Illinois Department of Transportation

SUBJECT: Aurora Municipal Airport
Sugar Grove, Illinois
Kane County
Illinois Project Number: ARR-4544
[SBG/AIP] Project Number: N/A
Contract No. AU072
Item No. 05A, November 17, 2023 Letting
Addendum A

NOTICE TO PROSPECTIVE BIDDERS

Sheet 13 Typical Sections – 1: Delete the Remove and Replace Bituminous Pavement – Type B Detail (Base Bid, Add. Alt. No. 2 and 3) and replace with the detail below.

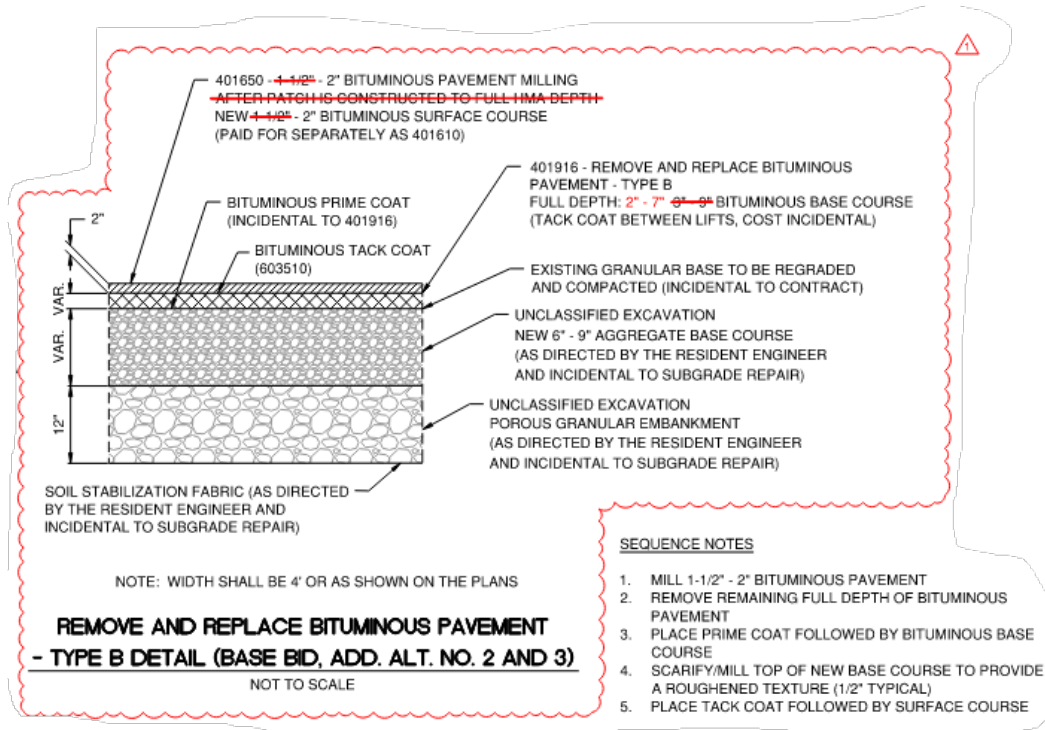
Remove and Replace Bituminous Type B is constructed after 401650 Pavement Milling. The Contractor shall use rollers meeting the minimum requirements as specified in Illinois Standard Specifications for Road and Bridge Construction, Adopted January 1, 2022.
